## DART SERVICE INSTRUCTION

TO AMEND INSTALLATION INSTRUCTIONS IIN-D119-756 REV. C & INSTRUCTIONS FOR CONTINUED AIRWORTHINESS ICA-D119-756 REV. 0
REF. TCCA STC SH06-39
REF. FAA STC SR02364NY

| REV. D     |                   | DESCRIPTION  | BY | DATE        |
|------------|-------------------|--|----|-------------|
| DE APPR.   | - <del>1</del> 41 | BASKET BASE ASS'Y CHANG  | Ε  | NTS         |

## FIGURE 1 - D119-756-041 HELI-UTILITY-BASKET

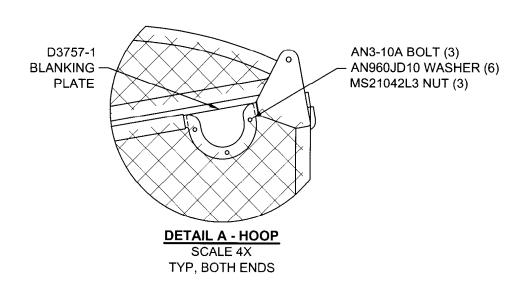
ON THE D119-756-041 HELI-UTILITY-BASKET AT CHG 002 OR LATER, THE FORWARD AND AFT ENDS OF THE D3516-041 BASKET BASE ASSEMBLY HAVE BEEN UPGRADED WITH HOOPS AND FITTED WITH D3757-1 BLANKING PLATES. THE D3757-1 BLANKING PLATES MAY BE REMOVED TO ALLOW THE OPERATOR TO RUN A CABLE OUT OF THE BASKET TO THE AIRCRAFT. IT IS THE RESPONSIBILITY OF THE OPERATOR TO ENSURE THAT THE CABLE IS PROPERLY SECURED FOR FLIGHT. REFER TO FIGURE 1 ON SHEET 2 OF THIS SERVICE INSTRUCTION.

THE PARTS LIST ON PAGE 14 OF IIN-D119-756 REV. C AND ON PAGES 41 AND 43 OF ICA-D119-756 REV. 0. SHOULD BE UPDATED AS FOLLOWS:
